## New pendulum for turkey drinker EasyLine

**Pendulum solid  
Item 4635-00**

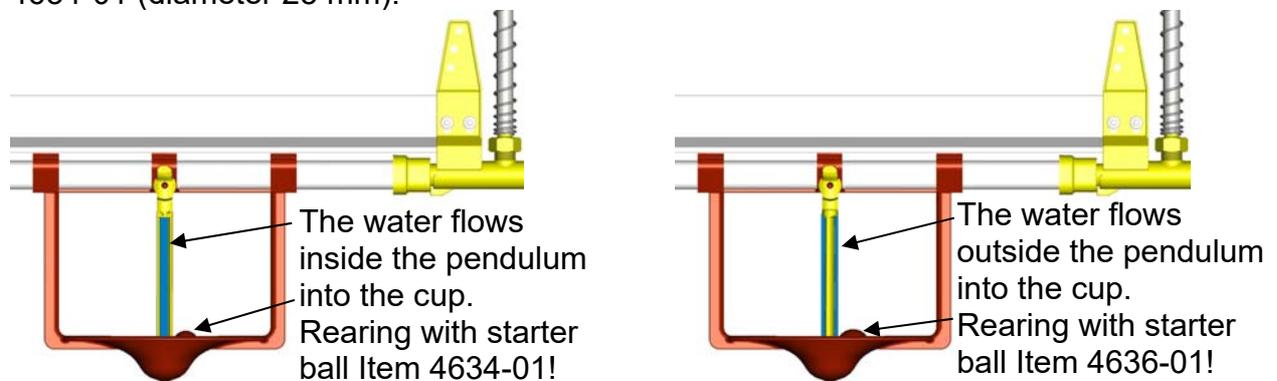
The new version of the pendulum for the turkey drinker EasyLine is closed. Thus the water flows not as before inside the pipe into the cup, but flows now outside at the pendulum into the cup (see sketch below).

The pendulums are exchangeable. For rearing the starter ball must be adapted the pendulum. For the new narrower pendulum the starter ball Item 4636-01 (diameter 30 mm) must be used. For the open version it remains with the starter ball with the Item 4634-01 (diameter 25 mm).
